Pōrangahau & Te Paerahi WWTP

Wastewater Treatment Strategy and Technology Selection - Review

Project:	Pōrangahau & Te Paerahi WWTP		
Our reference:	343853BA17	Your reference:	Pōrangahau & Te Paerahi WWTP
Prepared by:	Nick Dempsey	Date:	16 January 2023
Approved by:	Sven Exeter	Checked by:	David Hume & Sven Exeter
Subject:	Pōrangahau & Te Paerahi Wastewater Treatment Strategy and Technology Selection & Wastewater Consent Conditions

Figure 2.1: High Level WWTP Schematic

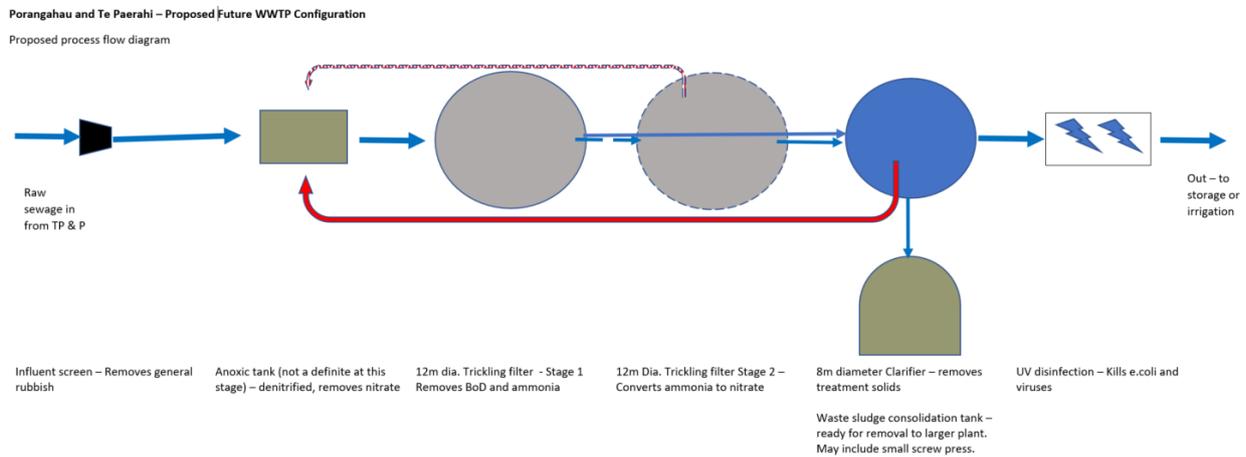
The process described above is a two-stage BTF, with an optional anoxic tank up front. Also included are up front screening, secondary sedimentation, and UV disinfection. We note that it is conventional to include a primary settlement tank (PST) upstream of BTF systems. There are some examples in NZ that do not include PSTs, but these typically require increased screening upstream to ensure that the BTF media is not compromised.

It is recommended that the anoxic tank which is shown as “not a definite” in the system diagram is installed. This will help to ensure that the BTF is at least equivalent at TN removal as the existing pond system (which is likely benefiting from ammonia volatilisation to remove TN). Including this step will also assist with pH management, potentially avoiding the need for pH correction through chemical dosing.

It is conventional to include a primary settlement tank (PST) upstream of BTF systems. There are some examples in NZ that do not include PSTs, but these typically require increased screening upstream to ensure that the BTF media is not compromised. It will be important to ensure that more intensive pre-screening is included if the final solution does not include a PST.
